Access Compliance Report

Public Rights-of-Way

Intersection ID: 26308	Main Street: WEDDINGTON_RD	Cross Street: MCKEE_RD	Location: NE
ADA ID: 3F169A26BB20	Ramp Type: BlendTrans1	Initial Pass/Fail: Pass	Overall Compliance: No
		Severity Score: 2.5

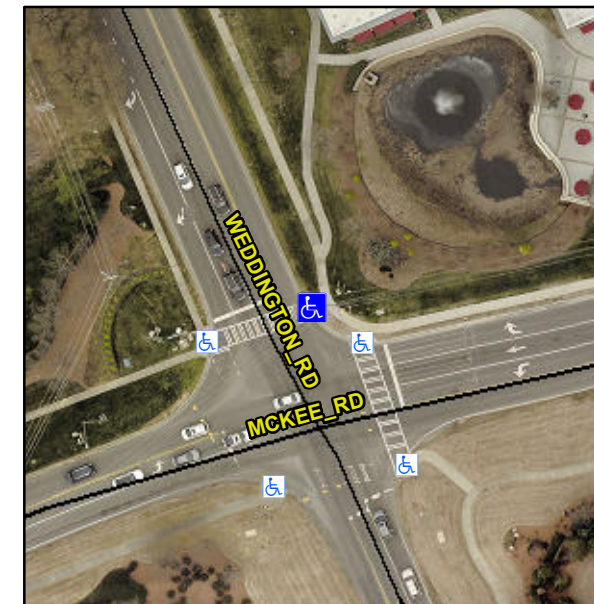
R304.2.2-Perp, R304.3.2-Para, R305.1.4, R305.2

Remove & Replace Curb Ramp With Two New Directional Ramps or Equivalent.
